**DATE:** JANUARY 14, 1999  
**MODEL YEAR:** 1995 ~ 1998  
**CHASSIS MODEL:** ALL MEDIUM DUTY  
**BULLETIN #:** AC - 07

## RED DOT AIR CONDITIONING REFRIGERANT HARDLINE HOSE CLAMPING

### PURPOSE

To announce the availability of new Red Dot components for the R-2190 model air conditioner found in 1995 ~ 1998 Medium Duty vehicles that will improve the separation and clamping of the two compressor hardlines at the side of the radiator and above the engine's charge air intercooler.

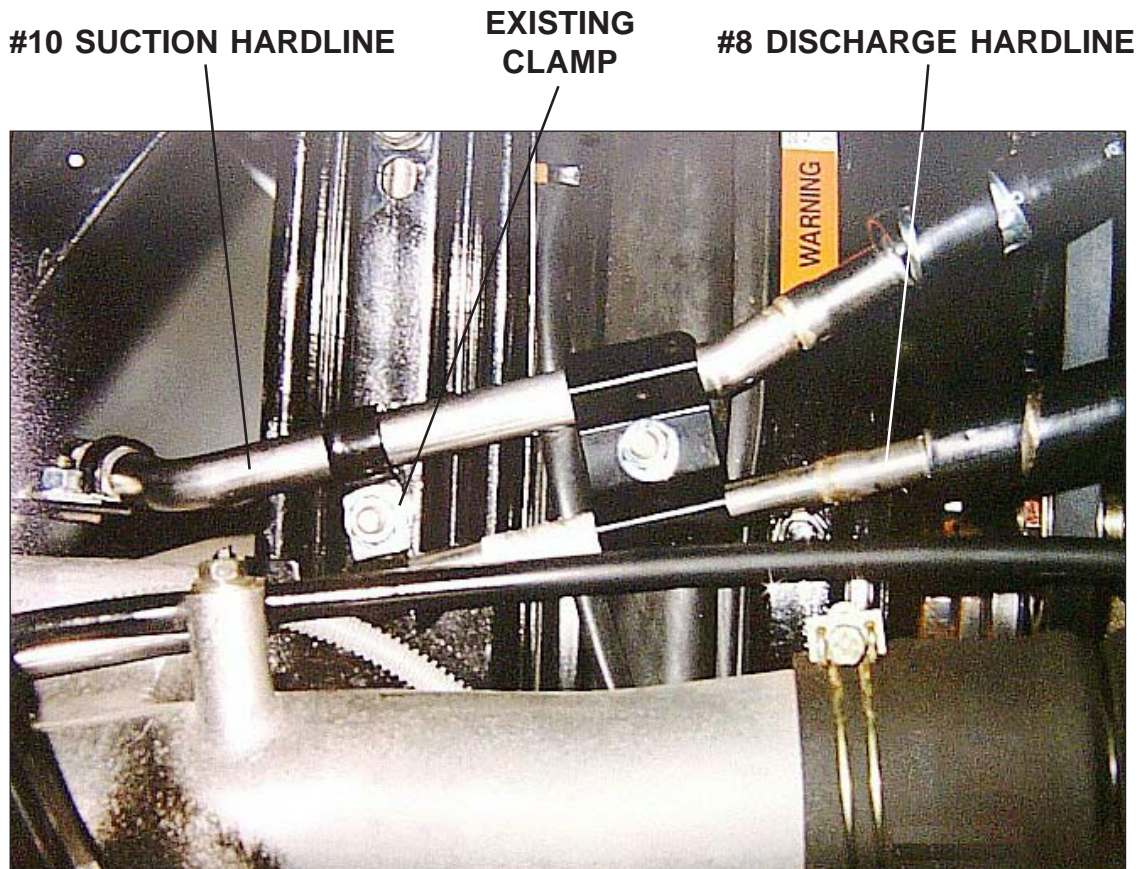
The compressor #10 suction hardline is clamped to the radiator left side panel with a tubing clamp as shown in the figure below. If the clamp should come loose, the #10 hardline can rub into the engine's charge air intercooler on the front side of the radiator and can also rub into the #8 discharge line causing damage to these items. New parts have been developed which secure and reposition the clamping of these two lines at the radiator side panel and above the charge air intercooler.

When these two lines are replaced or removed during service or repairs, the new parts should be added to the vehicle to prevent possible chaffing of the lines or the charge air intercooler.

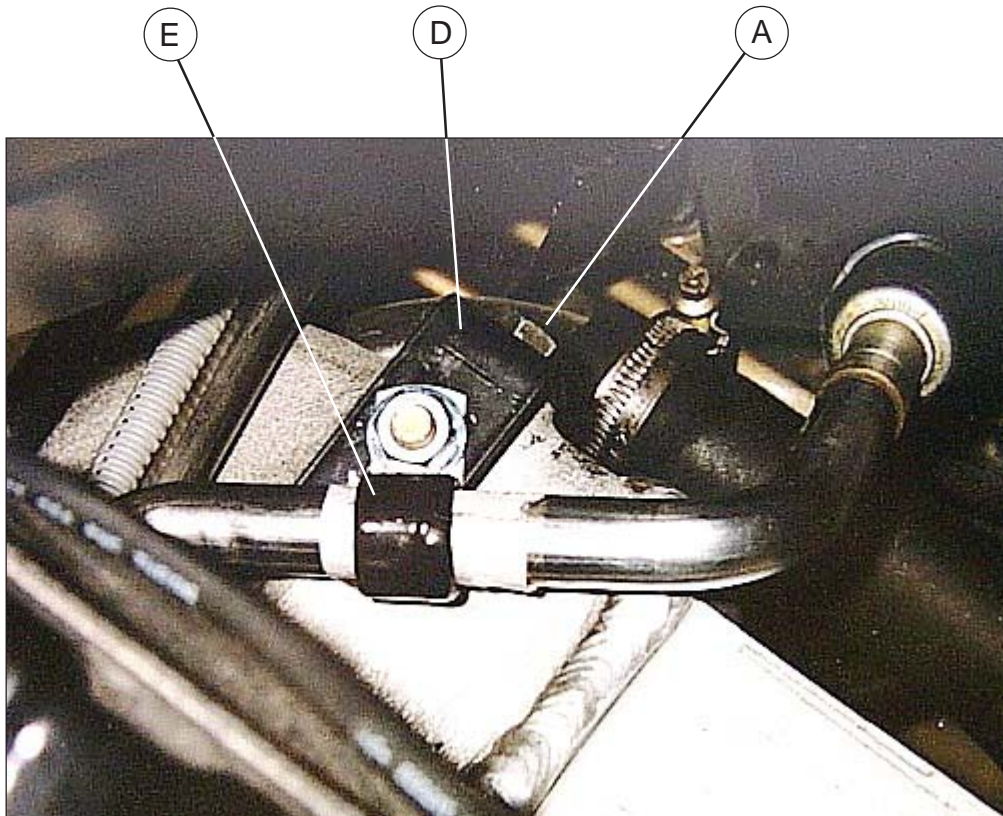
Loosely install the 2-piece hardline spreader and spreader clamp (items B and C) on the metal portion of the hardlines approximately 3" to the rear of the existing radiator side clamp location. Please note that the hardline spreader and matching spreader clamp have a large clamp opening for the #10 suction hardline and a smaller clamp opening for the #8 discharge hardline.

2. Remove and discard the existing bolt located at the top left hand side of the vehicle (driver's side) that attaches the charge air intercooler to the radiator.

Install the locating bracket (item D) at this location using the new bolt (item A) as shown in the figure below and tighten the bolt to 19 N·m (1.9 kg·m) (14 lb·ft).

3. Install the new tubing clamp (item E) over the #10 suction hardline and attach the clamp to the locating bracket.
